Ship Watertightness and Damage Stability

Amended Rules and Guidance

Rules for the Survey and Construction of Steel Ships Parts C, CS, and D
Rules for the Survey and Construction of Passenger Ships
Guidance for the Survey and Construction of Steel Ships Part D
Guidance for the Survey and Construction of Passenger Ships

Fig.2.3.2-2 has been added as follows.

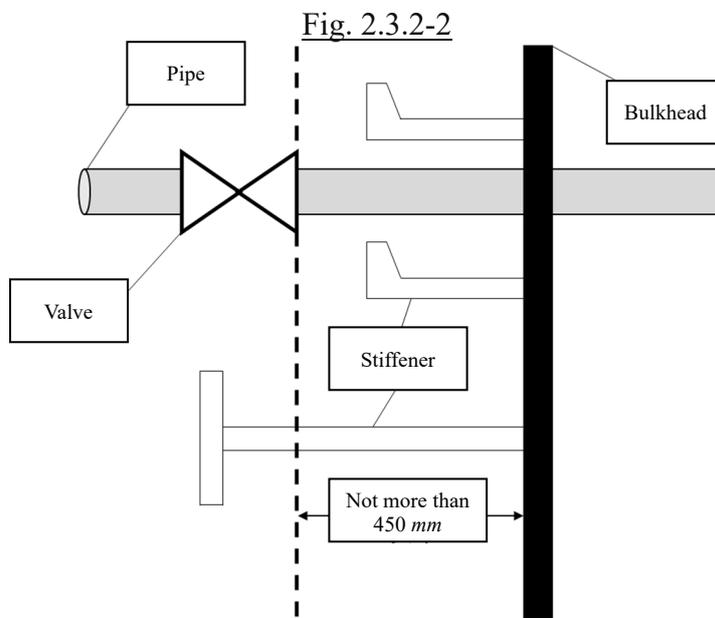
11 Pipes and valves directly adjacent or situated as close as practicable to a bulkhead or to a deck can be considered to be part of the bulkhead or deck, provided the separation distance on either side of the bulkhead or deck is of the same order as the bulkhead or deck stiffening structure. The same applies for small recesses, drain wells, etc. In no case is the separation distance on either side of the bulkhead or deck to be more than 450 mm measured from the valve's near end to the bulkhead or deck. An example is shown in Fig. 2.3.2-2.

Fig. CS4.2.2 has been added as follows.

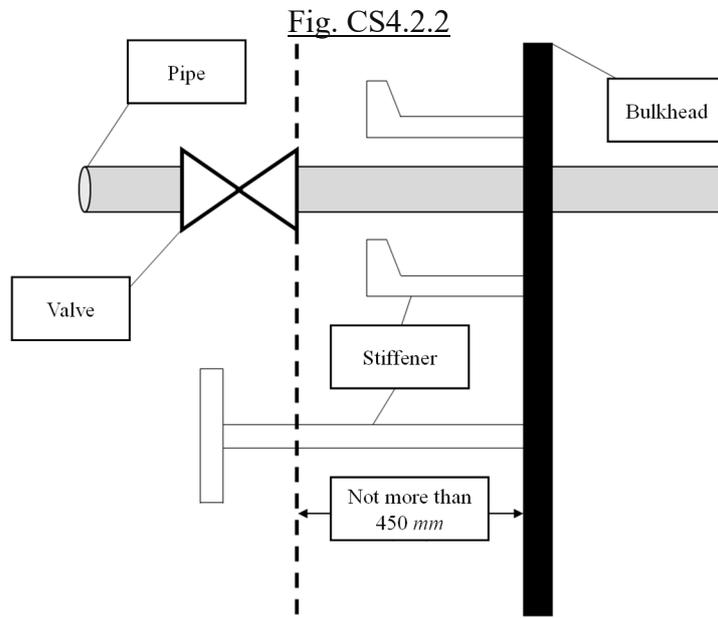
8 Pipes and valves directly adjacent or situated as close as practicable to a bulkhead or to a deck can be considered to be part of the bulkhead or deck, provided the separation distance on either side of the bulkhead or deck is of the same order as the bulkhead or deck stiffening structure. The same applies for small recesses, drain wells, etc. In no case is the separation distance on either side of the bulkhead or deck to be more than 450 mm measured from the valve's near end to the bulkhead or deck. An example is shown in Fig. CS4.2.2.

Fig. 4.2.3.4-2 has been added as follows.

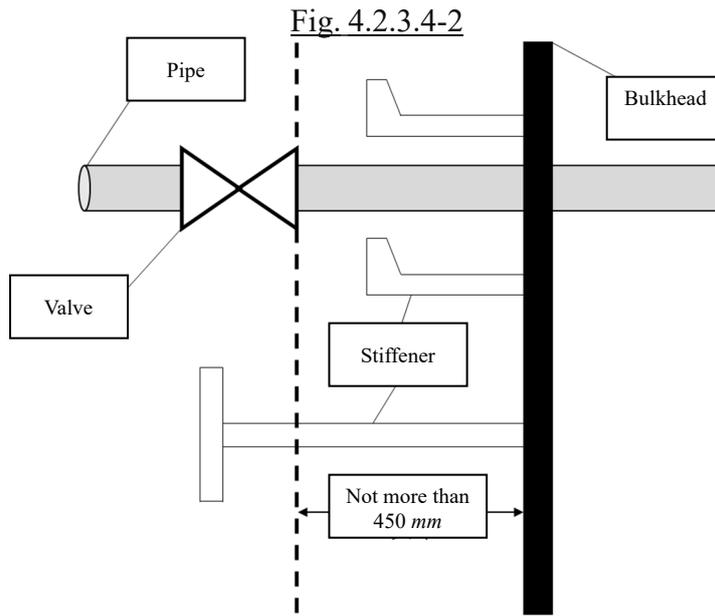
6 Pipes and valves directly adjacent or situated as close as practicable to a bulkhead or to a deck can be considered to be part of the bulkhead or deck, provided the separation distance on either side of the bulkhead or deck is of the same order as the bulkhead or deck stiffening structure. The same applies for small recesses, drain wells, etc. In no case is the separation distance on either side of the bulkhead or deck to be more than 450 mm measured from the valve's near end to the bulkhead or deck. An example is shown in Fig. 4.2.3.4-2.

Fig. 4.2.3.5 Examples of Assumed Vertical Plane (In case of single damage zone)

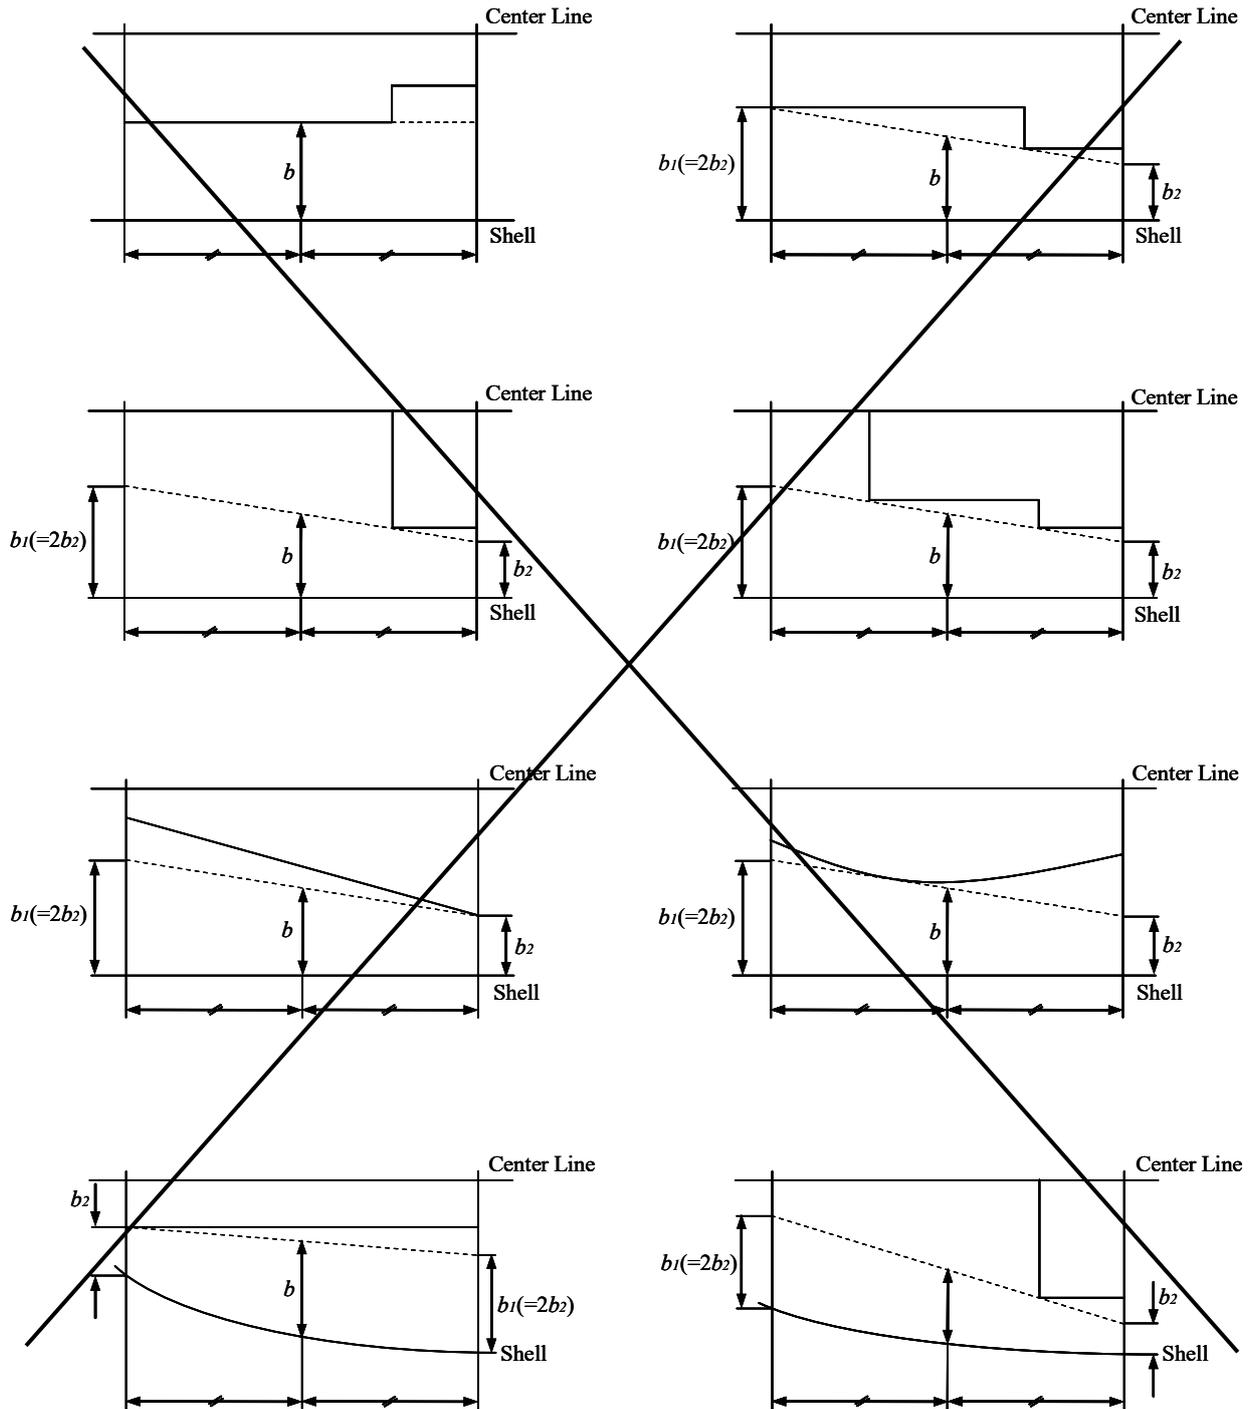
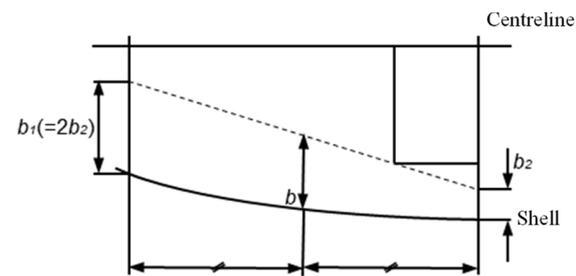
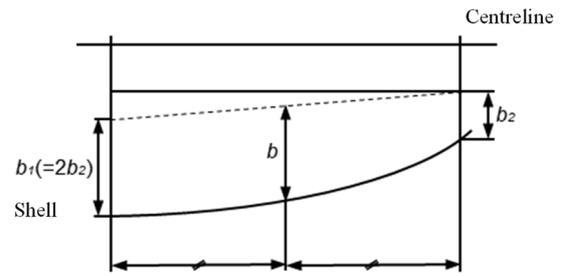
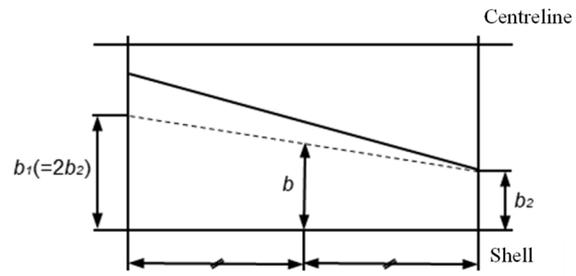
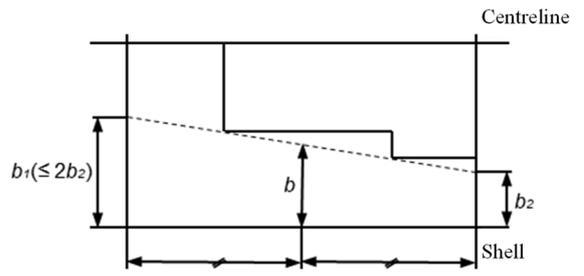
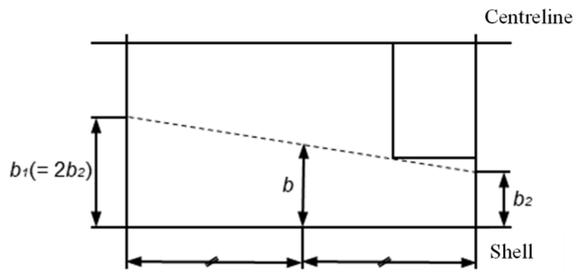
In application of the requirement of 2.3.5-1, Part 4 of the Rules, in case where the longitudinal bulkhead is not paralleled to the side shell plating, the assumed vertical plane which is considered in the determination of transverse distance (b) between longitudinal bulkhead and side shell plating is to be refer to a example specified in Fig. 4.2.3.5.

Fig. 4.2.3.5 has been amended as follows.
